FIELD SERVICE BULLETIN

FSB Number: LVCCFSB2006- 280
Author: Eduardo Rodriguez
Date: June 7, 2006
Total No. of Pages: 2
Subject: 3G V3x – Protective Clear Liner Obstructing Earpiece
Phone Models: 3G V3x
Level of Repair: 1

Fig. 2 Protective Plastic Color Implementation

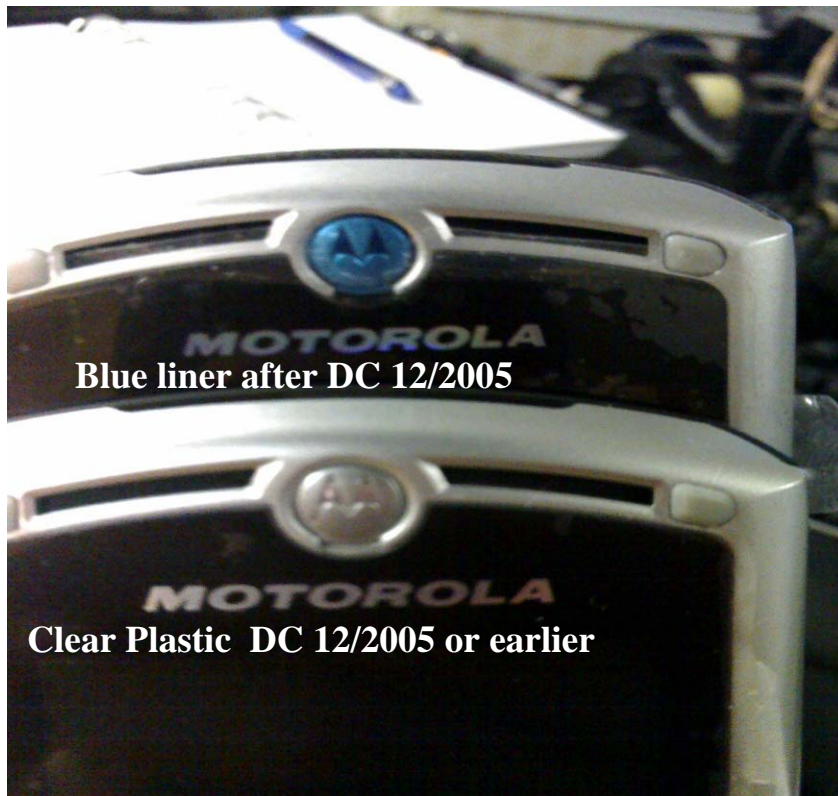
Blue liner application, over the flip earpiece Moto logo, was implemented by Foxconn in 122005, see fig 2.
